VERMONT YANKEE NUCLEAR POWER CORPORATION

September 16, 1999
BVY 99-115

Subject: Vermont Yankee Nuclear Power Station
 License No. DPR-28 (Docket No. 50-271)
 Response to Request for Additional Information Regarding
Spent Fuel Pool Storage Capacity Expansion

Response to Request for Additional Information Regarding
Spent Fuel Pool Storage Capacity Expansion
(Civil and Mechanical Engineering Considerations)

Figure RA: 1.8

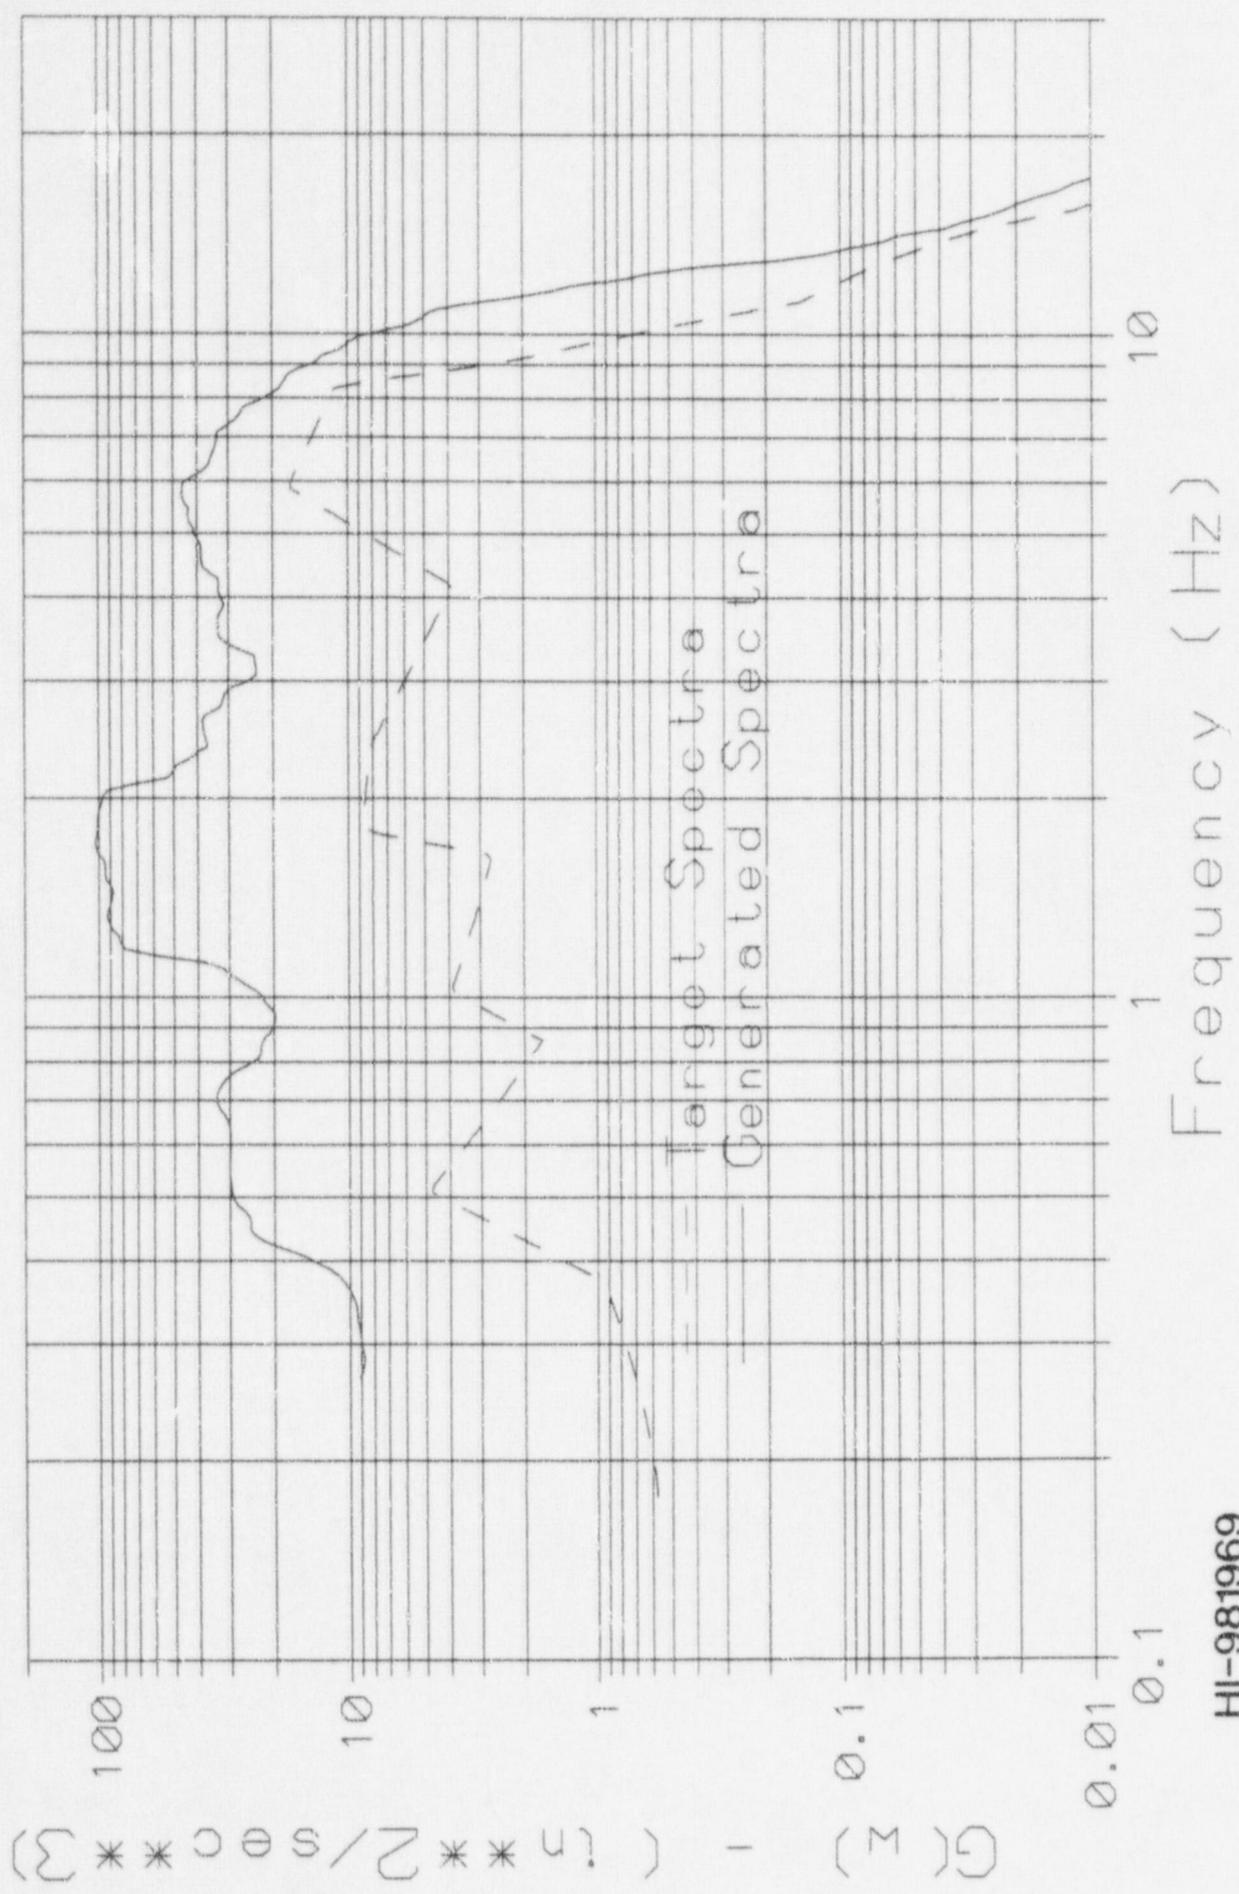
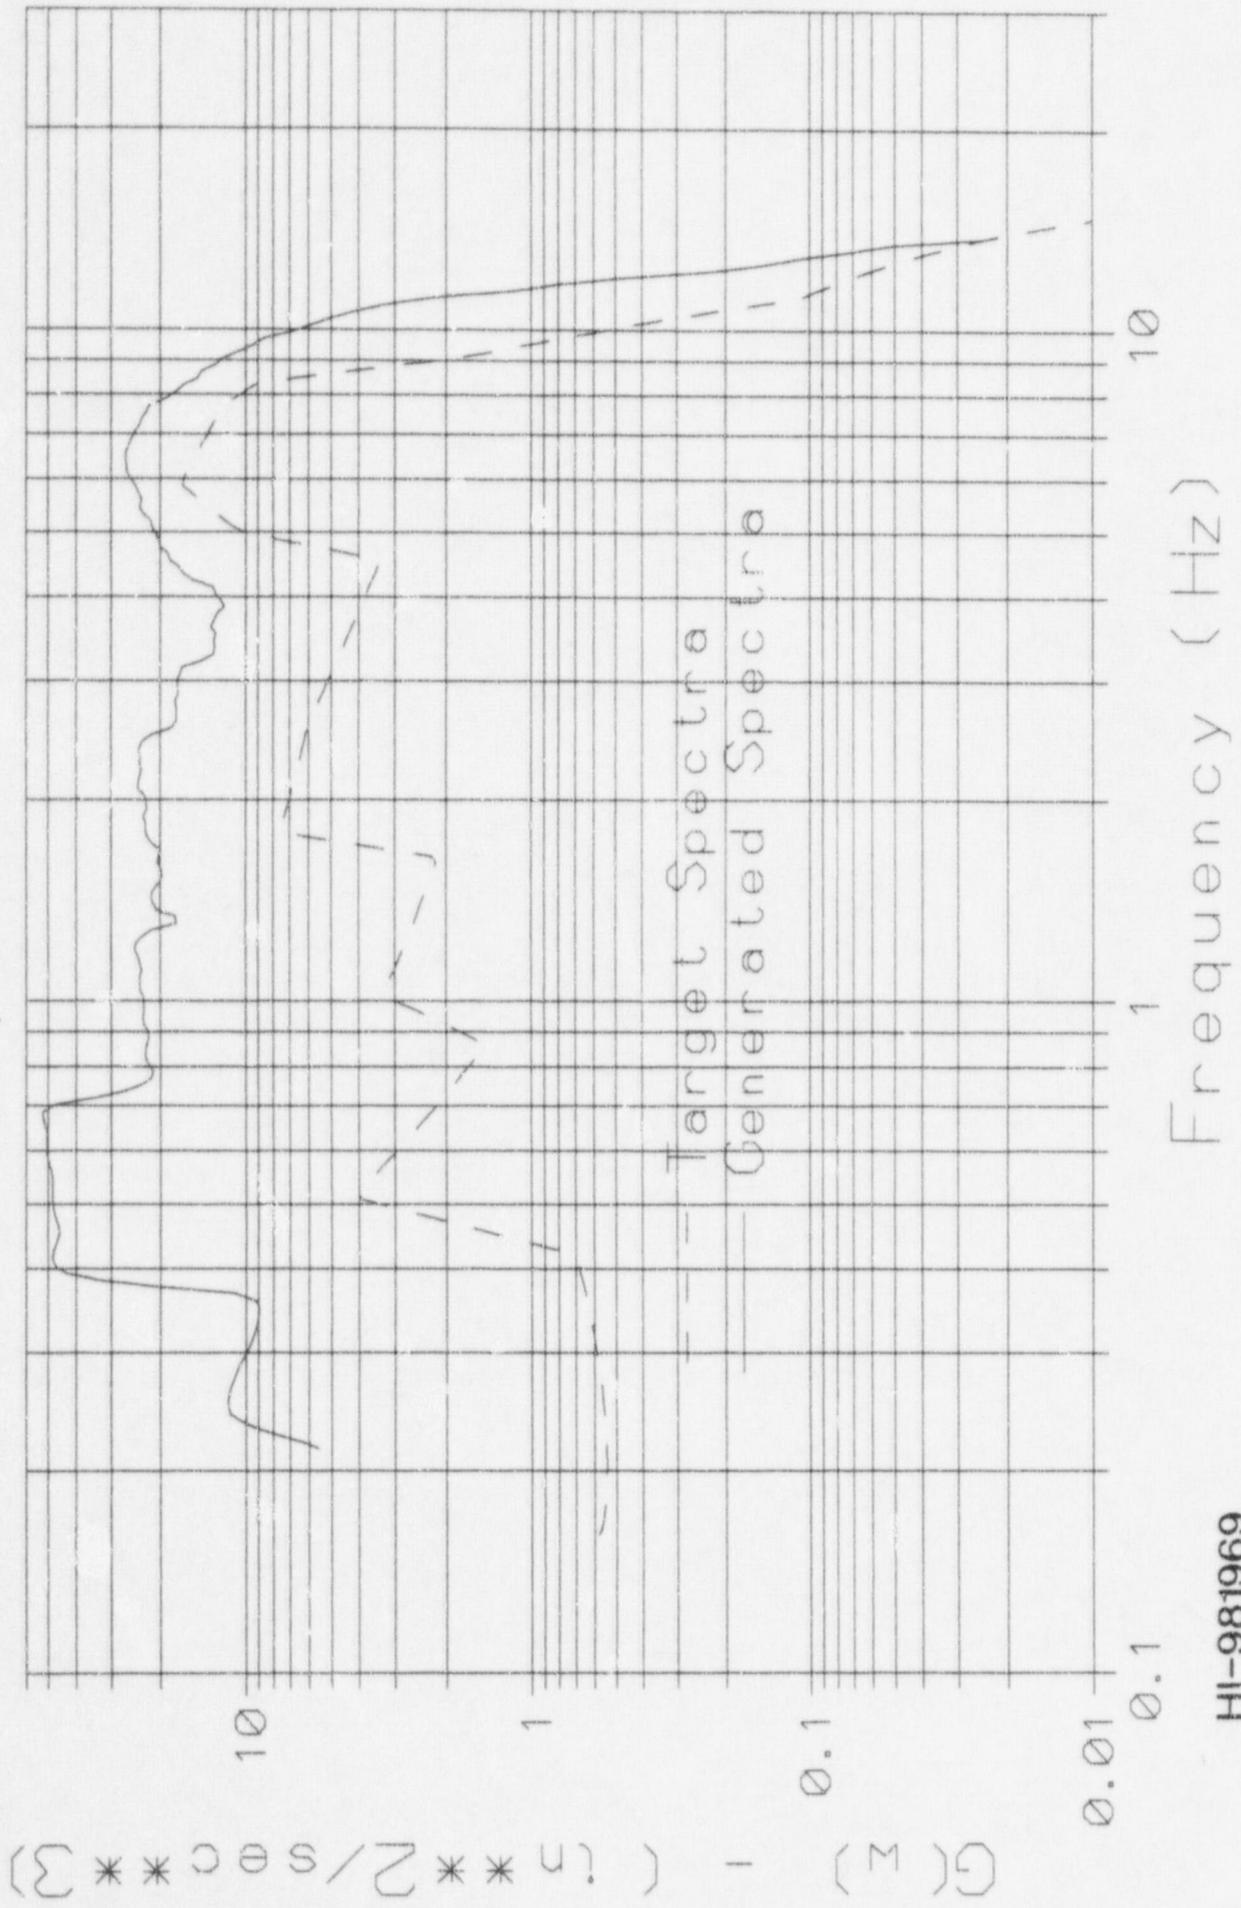
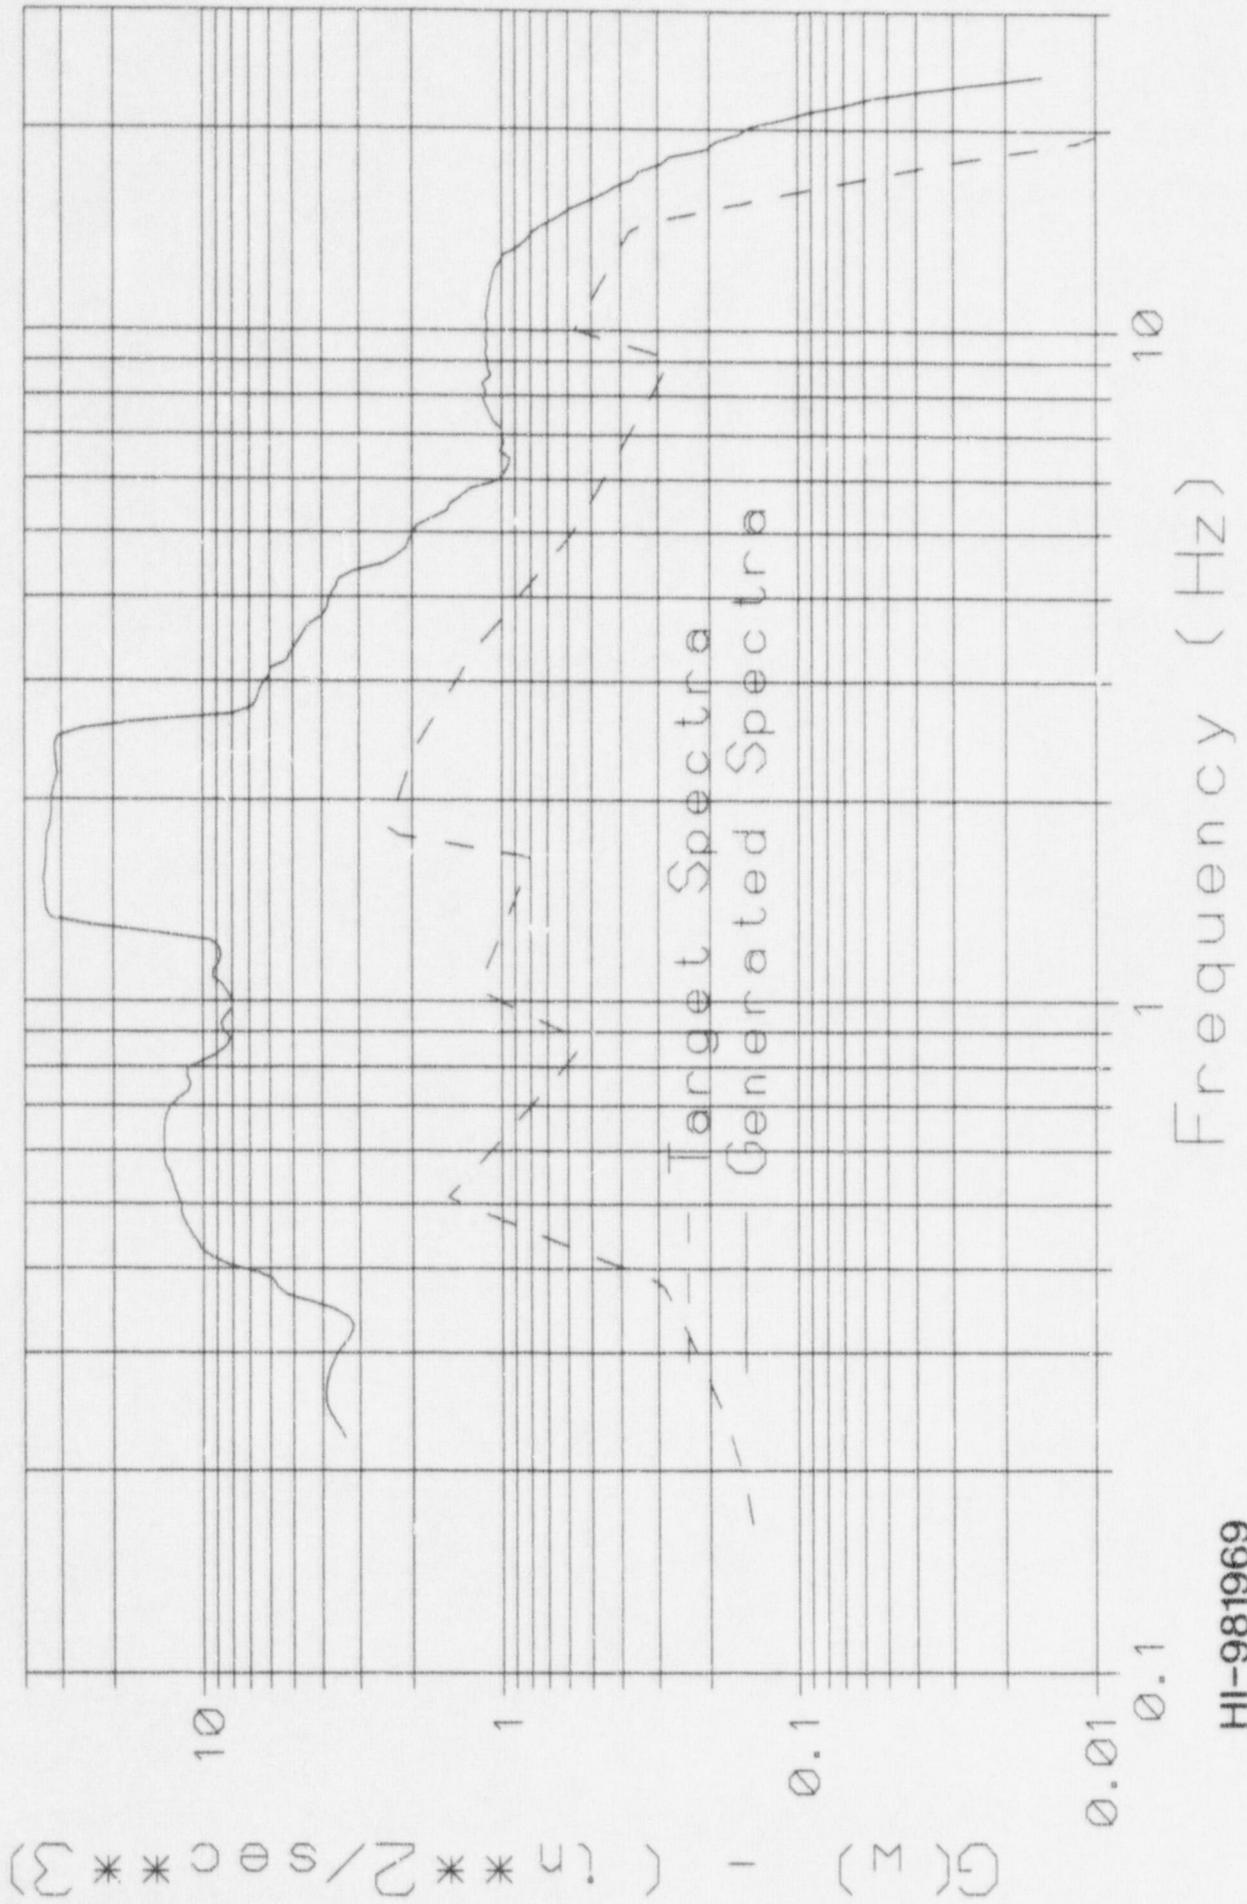
- e) Demonstrate that the artificial seismic time histories used in the analyses satisfy the power spectral density (PSD) requirement of Standard Review Plan (SRP) Section 3.7.1.

Holtec Report HI-981969 provides the details of the development of the time histories used for the Vermont Yankee pool from the design basis Response Spectra. Figures RAI 1.4-1.9, reproduced from that report, demonstrate the required enveloping of the target PSD, over the frequency range important to spent fuel racks (3-7Hz) by the PSD regenerated from the developed time histories.

FIGURE 2.1: POOL LAYOUT FOR VERMONT YANKEE

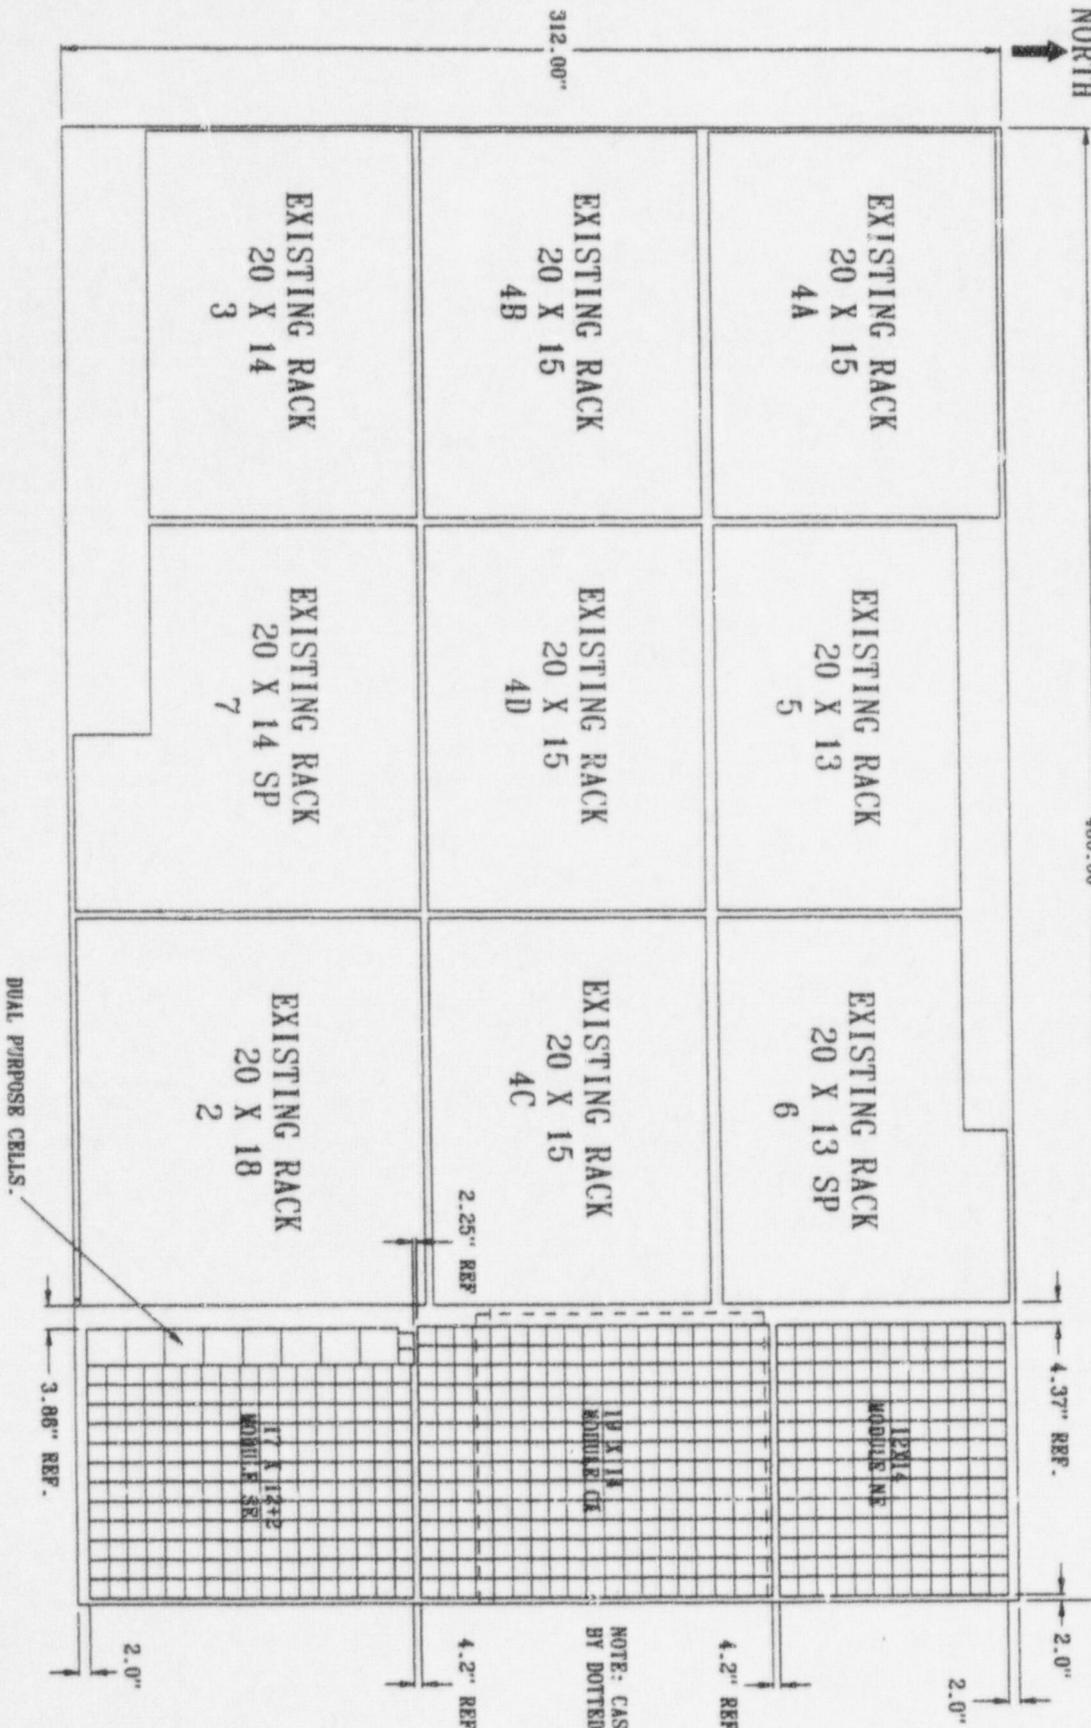
- c) Provide the stiffness calculations for the rack used in single rack analysis for the three (North-South, East-West and Vertical) directions.
- d) Provide the physical dimensions of the racks, gaps between the racks, and the gaps between the racks and the walls.

The requested data, which has been excerpted from Holtec International Report HI-981932, is provided in attachment 1K.
